## **Section 106 Assessment of Effects Report**

# **Appendix B: Consulting Party Meeting Minutes and Written Comments Received**

**Martin Luther King, Jr. Memorial Library Rehabilitation &  
Modernization** 901 G Street, NW, Washington, DC

November 20, 2015 | Prepared on behalf of the National Capital Planning Commission

*Neue Nationalgalerie, Berlin*

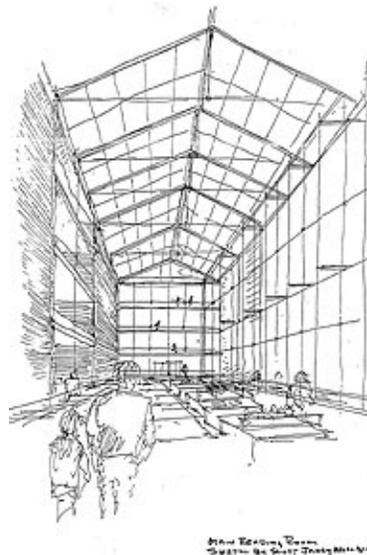
The MLK Library Friends also supports the removal of all brick walls—interior and exterior—and replacement with glass where necessary. Greatly increasing the transparency of the building will not only increase light, but it will also help draw people into the library, as well as share interior liveliness with the streetscape. Some of the brick elements have protected status as part of the historic landmark status of the building, but openness is a hallmark of the Modern architecture era and of Mies’ designs in particular. Many significant Mies buildings designed for cultural and educational purposes—including the Neue Nationalgalerie in Berlin and Crown Hall at the Illinois Institute of Technology—have walls made entirely of glass.

The MLK Library historical records show that brick was introduced only *after* marble specified by Mies was eliminated due to budget constraints. While we understand that buildings are landmarked *as built*, it is critically important to use this once in a lifetime opportunity for renovation of the MLK Library to make reasonable adaptations that will increase the appreciation and use of this public building and bolster its continued funding. Marble, had it been used, would be as lacking in transparency as brick, but worth saving for its beauty and association with grandeur. The brick, however, feels cheap and paltry in this setting, as indeed it is a substitute mandated by budget cuts. We endorse the replacement of brick with glass throughout.
